***REPLACEMENT PAGES FOR APPENDIX A
CRYSTAL RIVER UNIT 3
TECHNICAL SPECIFICATIONS***

3.7.15 Spent Fuel Assembly Storage

Figure 3.7.15-1 (page 1 of 3)
Burnup versus Enrichment Curve for
Spent Fuel Storage Pool A

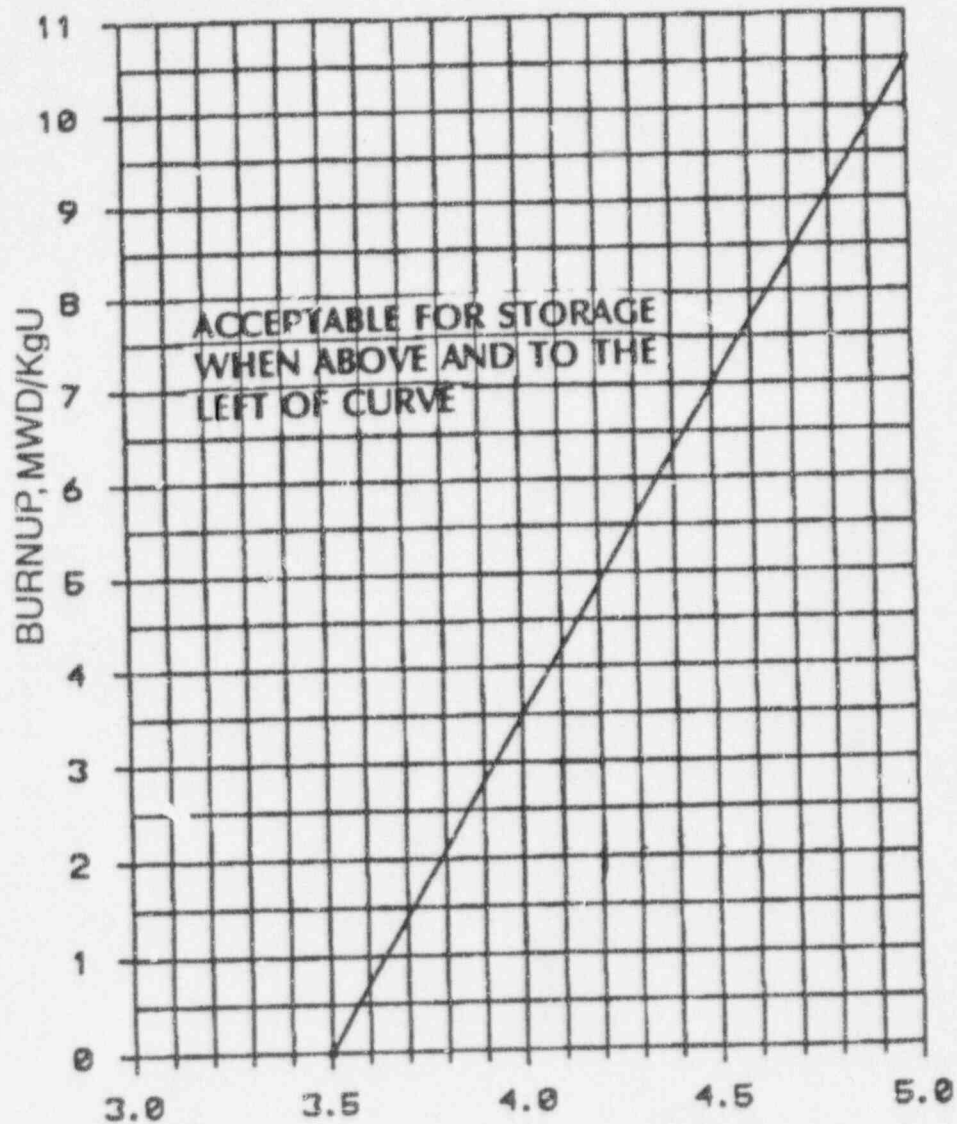
LCO 3.7.15 The combination of initial enrichment and burnup of each spent fuel assembly stored in Storage Pool A and Storage Pool B shall be within the acceptable region of Figure 3.7.15-1, Figure 3.7.15-2, Figure 3.7.15-3, or stored in accordance with the FSAR.

2. For spent fuel with initial enrichment less than or equal to 5.0 weight percent and greater than or equal to 3.5 weight percent, fuel burnup must be within the limits specified in Figure 3.7.15-1. (Figure 3.7.15-1 presents required fuel assembly burnup as a function of initial enrichment.)

Fuel enrichment limits are based on avoiding inadvertent criticality in the spent fuel pool. The CR-3 spent fuel storage system was initially designed to a maximum enrichment of 3.5 weight percent. Enrichments of up to 5.0 weight percent are permissible for storage in spent fuel pool A as long as the fuel burnup is sufficient to limit the worst case reactivity in the storage pool to less than 0.95. Fuel burnup reduces the reactivity of the fuel due to the accumulation of fission product poisons. Reference 1 documents that the required burnup varies linearly as a function of enrichment with 10500 megawatt days per metric ton uranium (Mwd/mtU) required for fuel with 5.0 weight percent enrichment and 0 burnup required for 3.5 weight percent enriched fuel.

Figure 3.7.15-2 (page 2 of 3)
Burnup versus Enrichment Curve for
Spent Fuel Storage Pool B, Region 1

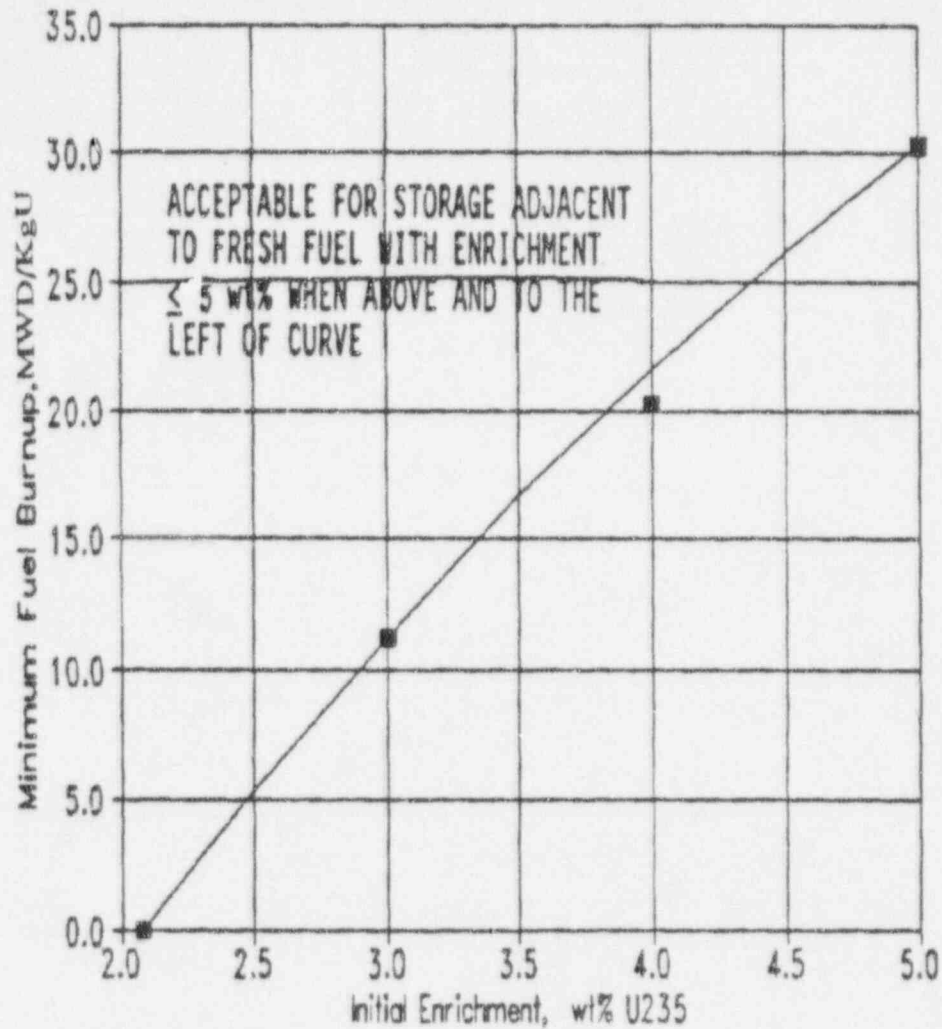
1. Initial fuel enrichment must be ≤ 5.0 weight percent U-235,
2. For Region 1, fuel with initial enrichment ≤ 5.0 weight percent and ≥ 2.08 weight percent fuel burnup must be within the limits specified in Figure 3.7.15-2 and arranged in a required checkerboard configuration with new fuel or burned fuel of ≤ 5.0 weight percent, and
3. For spent fuel with initial enrichment ≤ 5.0 weight percent and ≥ 1.63 weight percent in Region 2, fuel burnup must be within the limits specified in Figure 3.7.15-3. (Figure 3.7.15-3 presents required fuel assembly burnup as a function of initial enrichment.)
